## ADDENDUM 1 – JOB 47

TO: All prospective bidders on project TAU-8-984(154)157, Job No. 47 scheduled for the November 17, 2017 bid opening.

Addendum 1 is to address: Revising special provisions. Adding landscape boulders to protect path wall. Updating bridge quantities, details, notes.

REVISION 11/06/17	STATE	PROJECT NUMBER	SECTION NO.	SHEET NO.
	ND	TAU-8-984(154)157	170	7

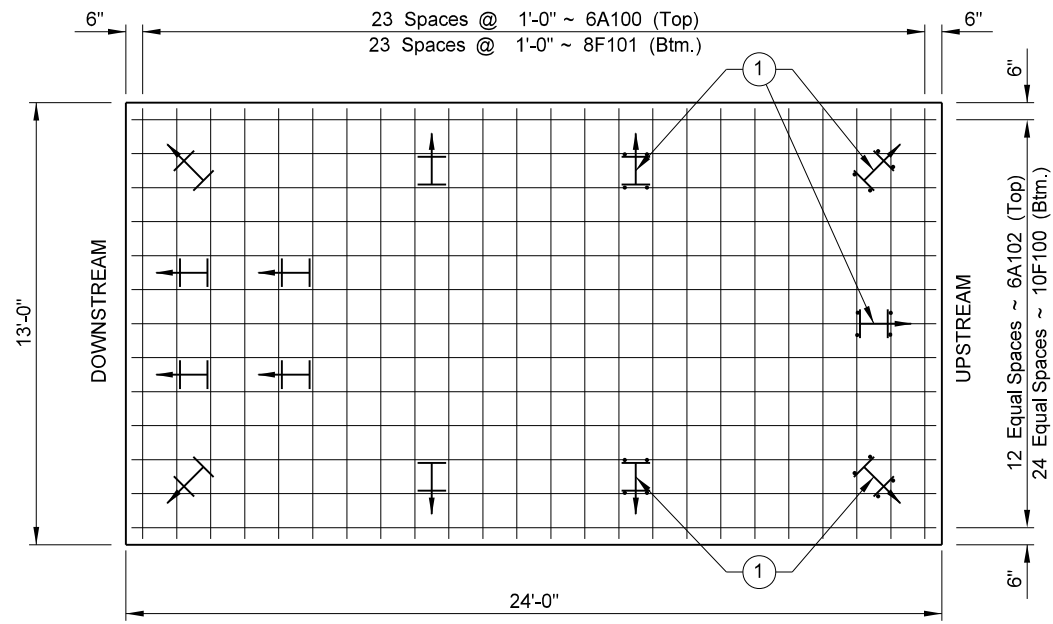
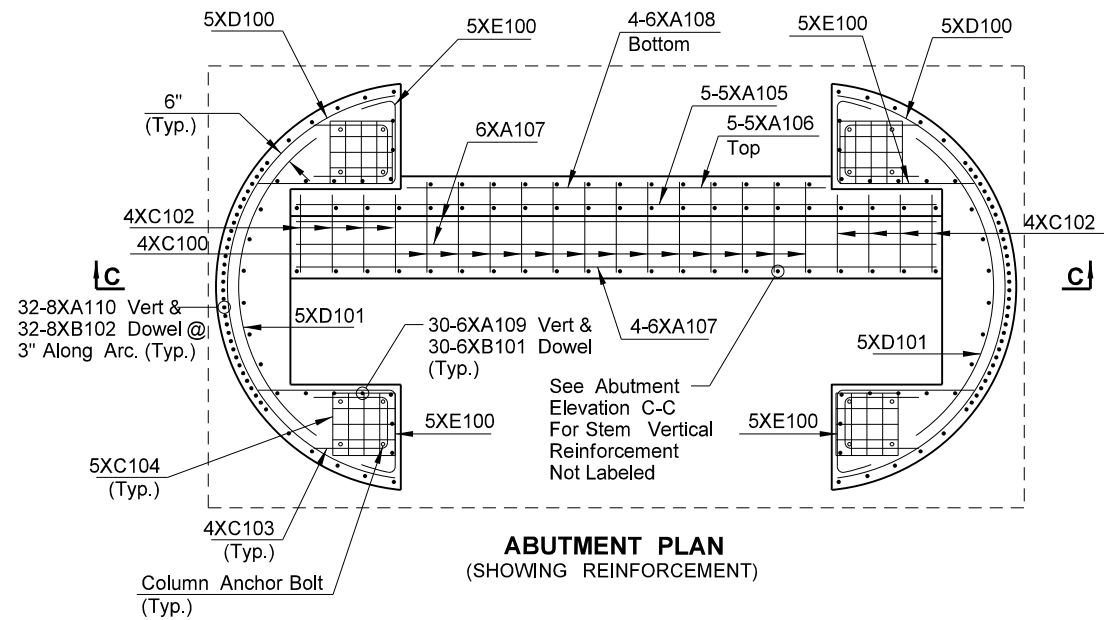
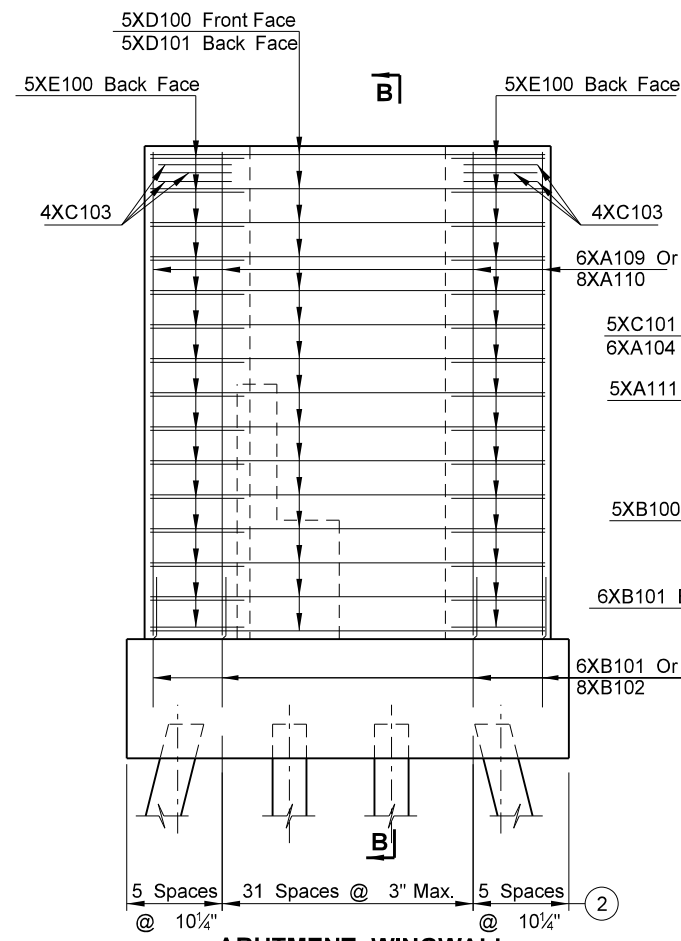
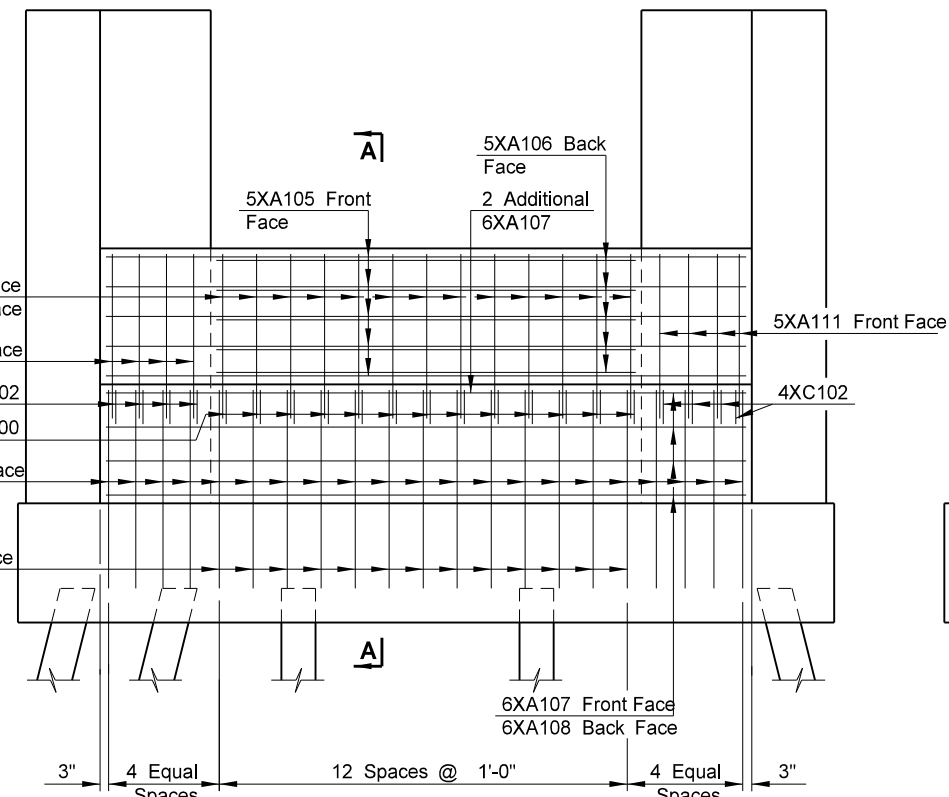
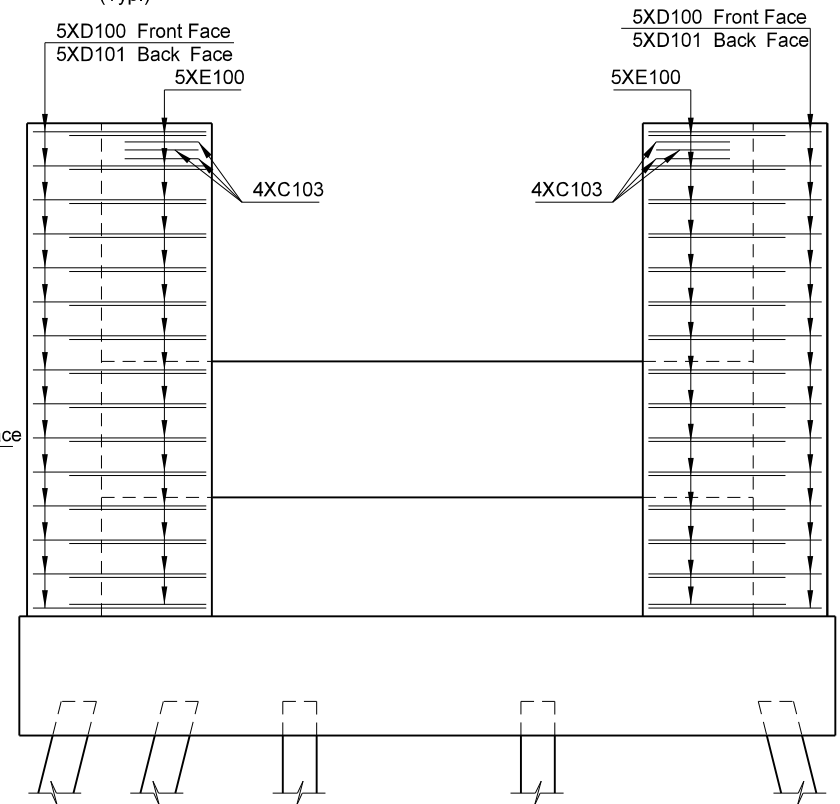
Pile added, column anchor reinforcing added and misc. text revisions.

REVISION 11/06/17	STATE	PROJECT NUMBER	SECTION NO.	SHEET NO.
ND		TAU-8-984(154)157	170	8

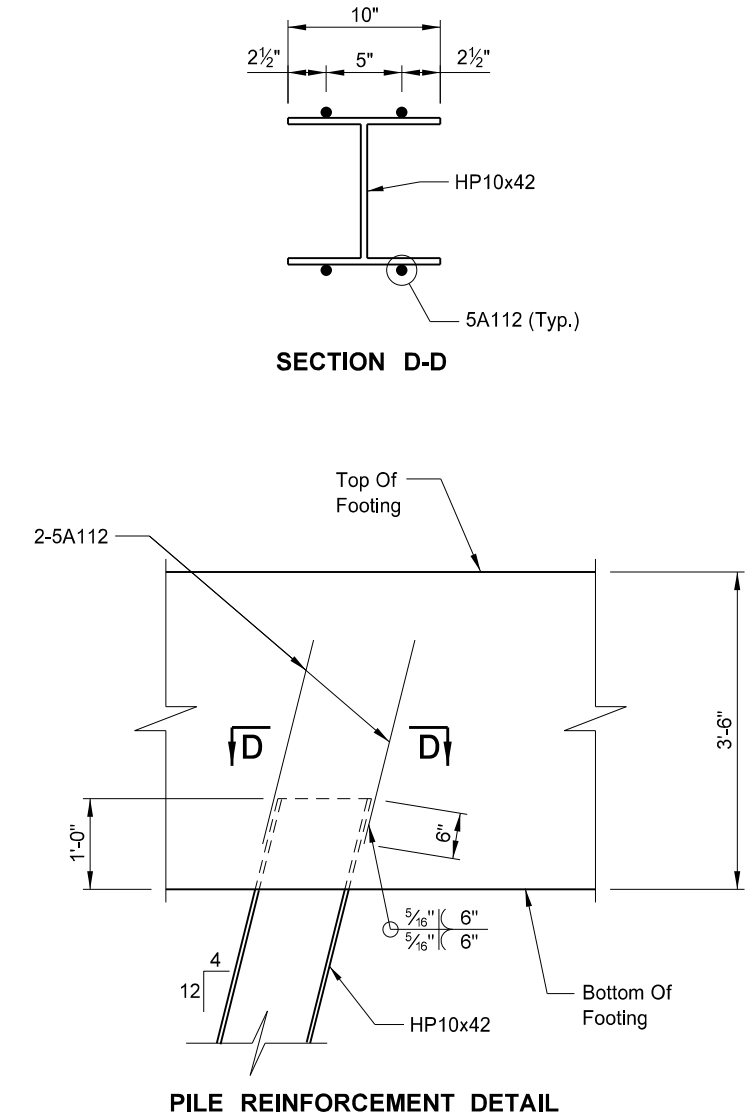
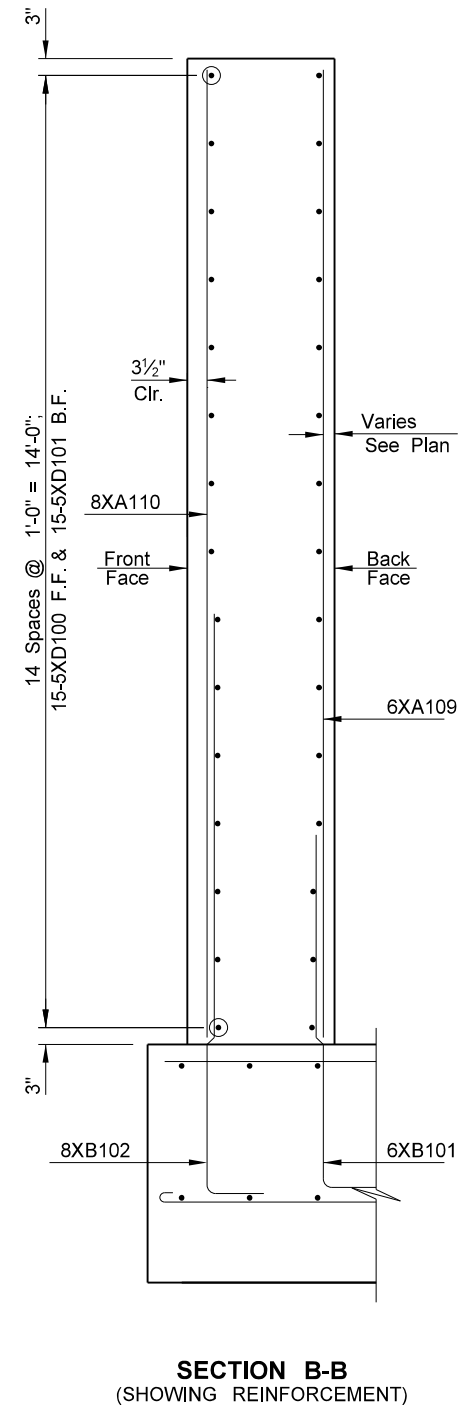
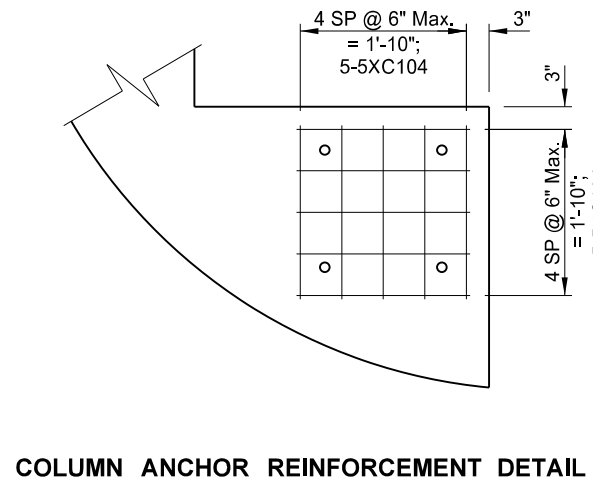
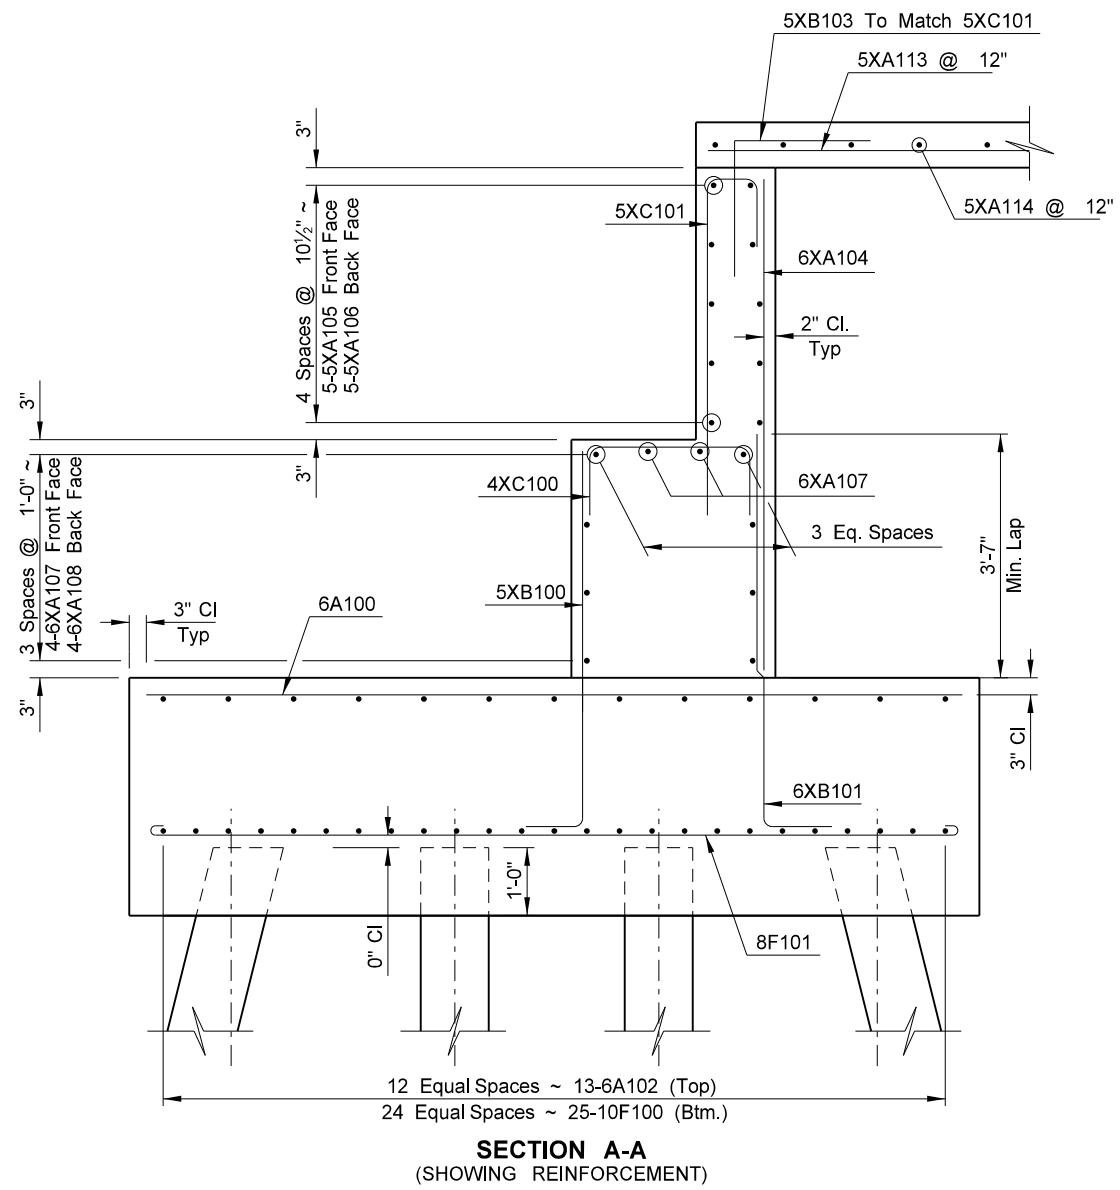
Column anchor reinforcement detail added and misc. text revisions.
